Agenda
Village of Arlington Heights
Design Commission
Community Room, 3rd Floor

Arlington Heights Village Hall
33 S. Arlington Heights Road
Arlington Heights, IL 60005
February 9, 2016
6:30 PM

**MINUTES OF
THE VILLAGE OF ARLINGTON HEIGHTS
DESIGN COMMISSION MEETING
HELD AT THE ARLINGTON HEIGHTS MUNICIPAL BUILDING
33 S. ARLINGTON HEIGHTS RD.
JANUARY 26, 2016**

PROJECT NO.

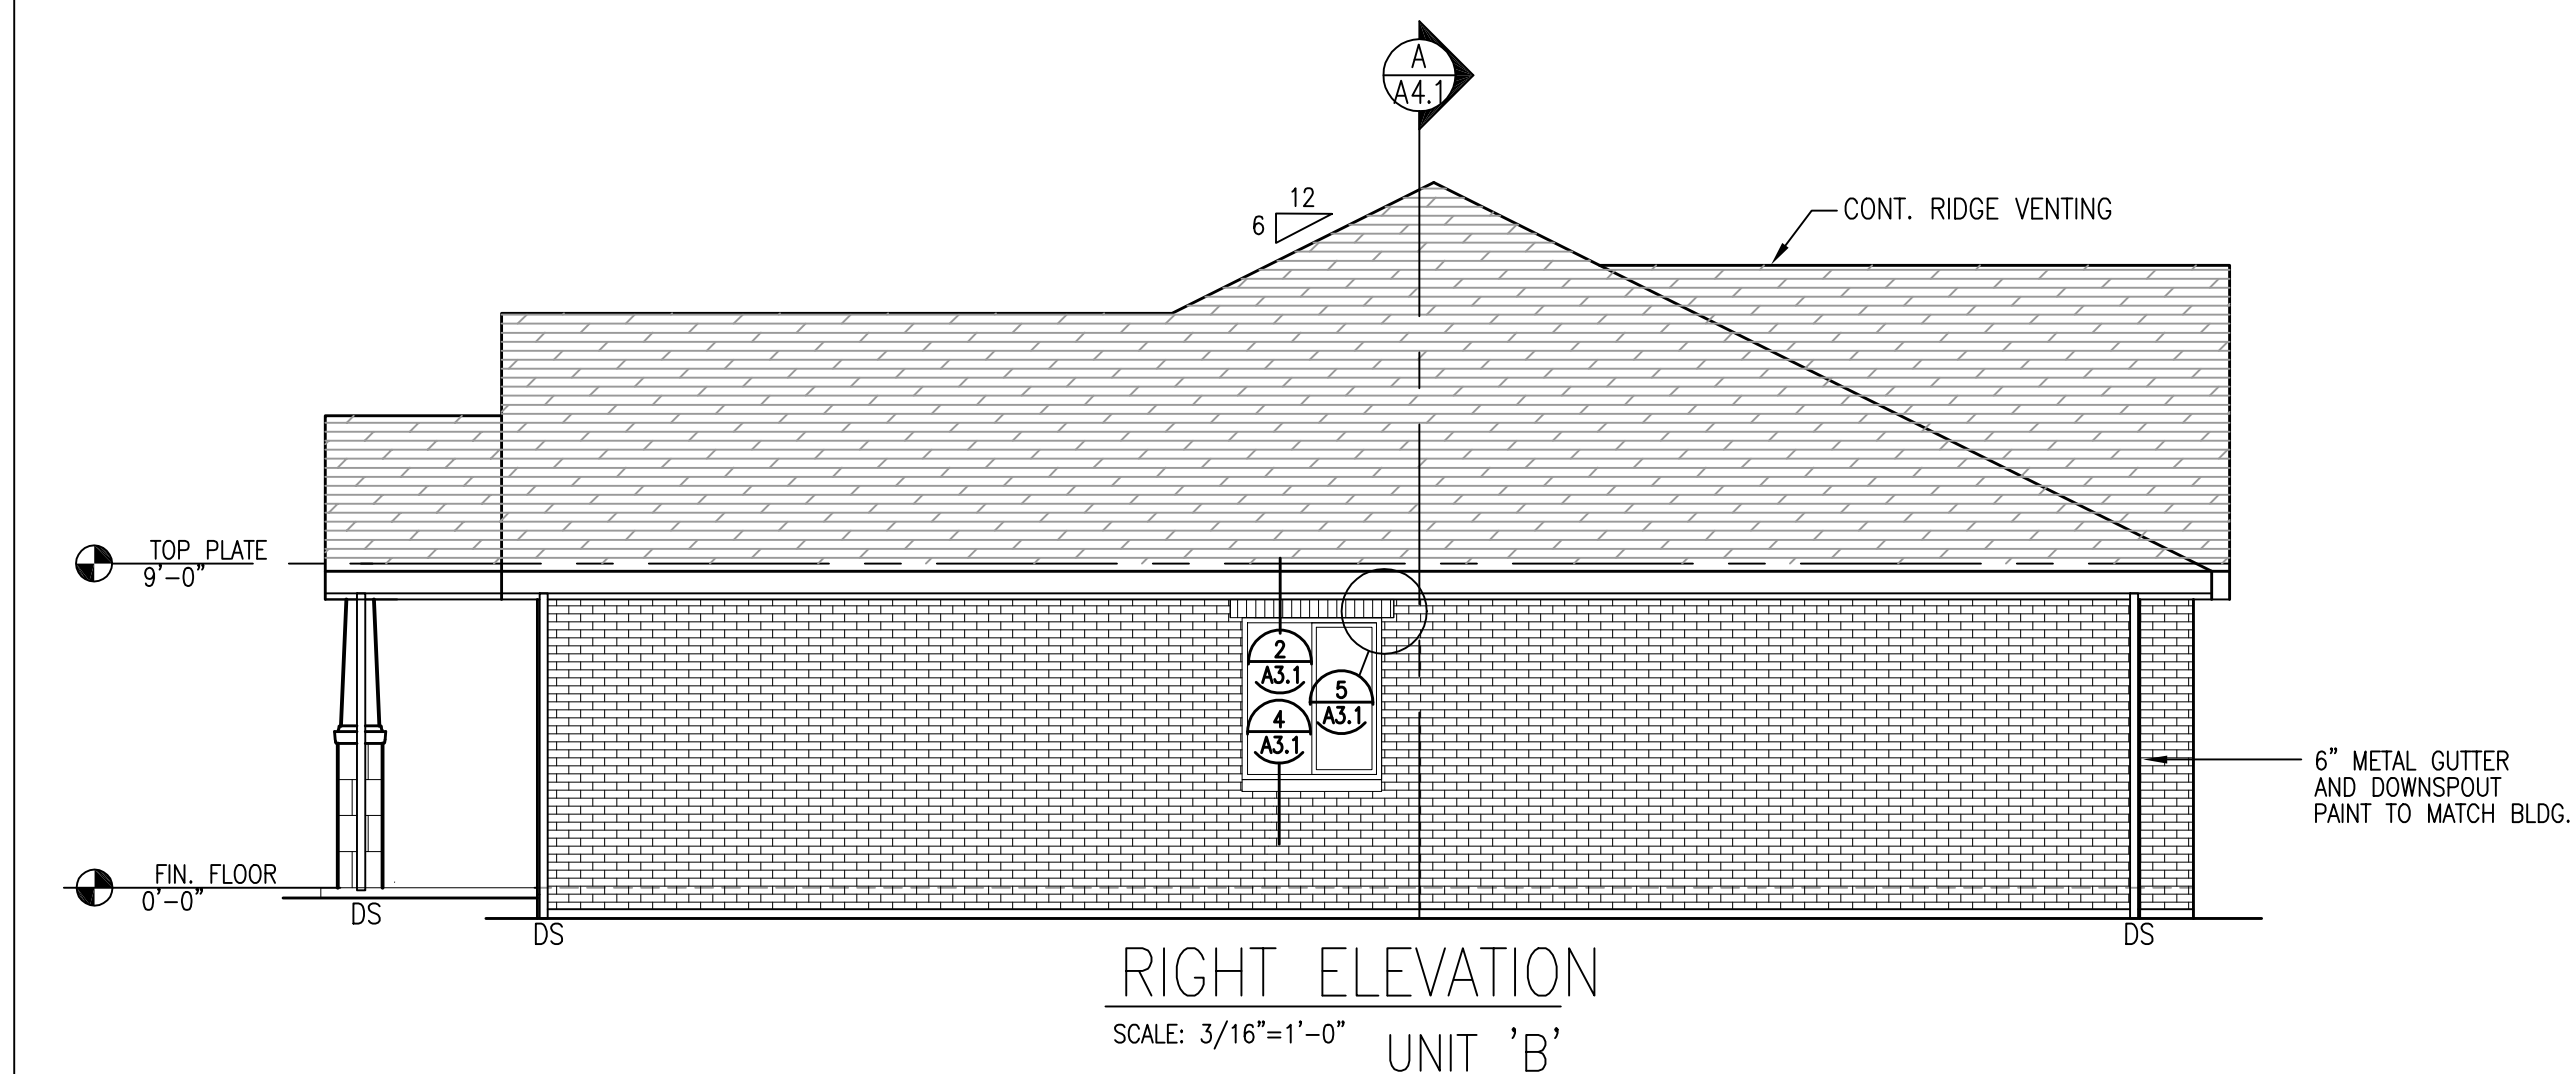
1. It is recommended that the rooftop equipment be moved to the courtyard side of the roof so that it will not be visible.
2. In place of the mechanical screen, provide two of the decorative triangular dormers on the east side of the roof to break up the expanse of roofing and to match the other sides of the building.

3. Relocate the rooftop mechanical equipment to the courtyard side of the roof.
4. Provide two decorative triangular dormers on the east side of the roof.
